AGENDA MILFORD PLANNING BOARD Tuesday, October 6, 2020

Re: 97 Cedar Street – Proposed Gas Station with Convenience Store
Site Plan Review – **2nd review letter**

Re: **156 West Street – Sky Pet Care**
Amended Site Plan Review

Figure 9
 2022 No Build Conditions
 AM, PM & SAT Peak Hours

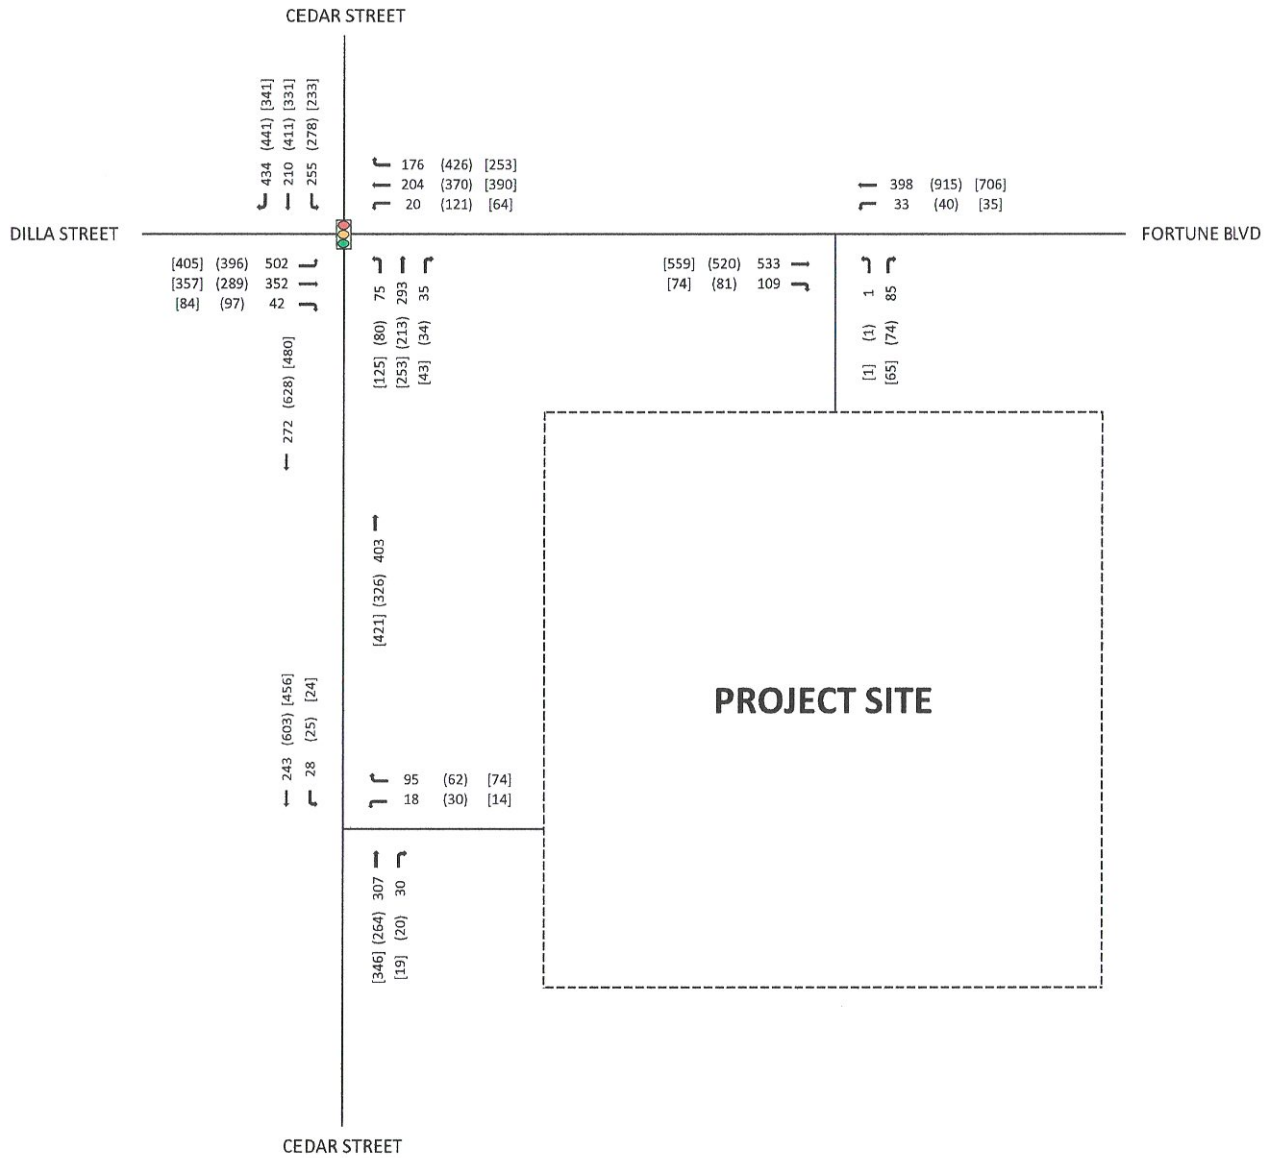
2. In my first report regarding the Traffic Impact Study (TIS), my comment # 8 stated:

- a. *“The TIS states or references ‘Optimize signal timing directive’. This should be discussed further with the applicant’s representatives to determine precisely what this means, as some portions of the intersection (Cedar Street, Fortune Blvd, & Dilla Street) will be operating at a Level of Service (LOS) ‘F’. If phasing or other mitigating measures are going to take place there should be plans or other documents defining what these changes will be. A Traffic Peer Review may then be warranted.”*

Once again, the response references **“can be implemented by the Town”**. The applicant should be responsible to prepare the revised timing/phasing plans and hire contractors that are qualified to implement such upgrades.

Response: The Traffic Impact Study’s capacity analysis has been updated to include the most recent version of the traffic signal timing directive, provided by the Town of Milford, for the intersection of Cedar Street (Route 85) with Fortune Boulevard/Dilla Street, which was not available to the Applicant at the time the Traffic Impact Study was first submitted. The following table details the level of service for the 2022 No Build and Build conditions based on the Town’s directive.

Under the 2022 Build condition, all movements at the intersection of Cedar Street (Route 85) with Fortune Boulevard/Dilla Street will continue to operate at or near No Build levels of service during all peak hours studied. The 2022 No Build and Build traffic volume figures and capacity analysis worksheets are appended to this letter. Based on our revised analysis, there is no change in level of service or delay from the No Build condition to the Build condition. Therefore, no modification to the signal timing is required.

SKETCH PLAN

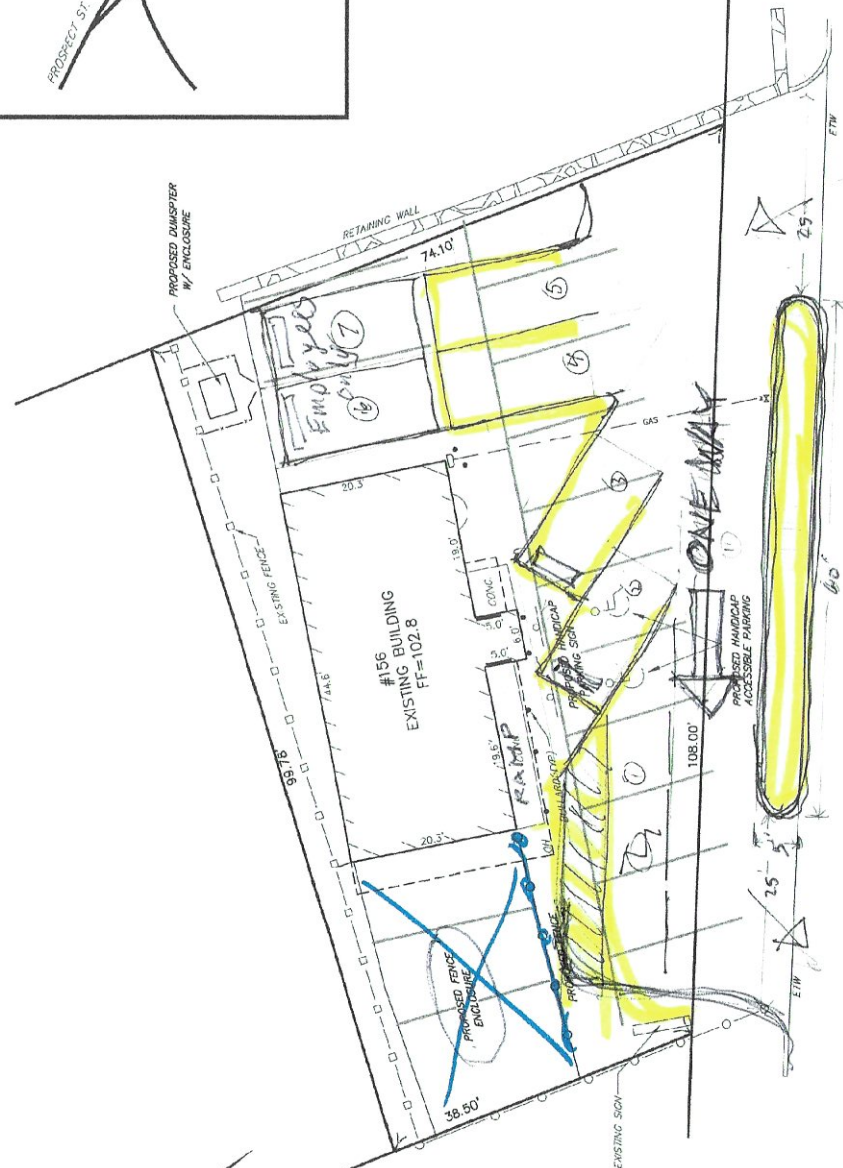
In addition to the above-listed deficiencies, the existing driveway is 110' wide across the entire frontage of the lot. A raised 60'-long median should be installed along the curb line to provide for a one-way traffic pattern. A 25'-wide entrance drive and a 25'-wide exit drive should be retained at each end of the raised median. A sketch plan is attached for reference.
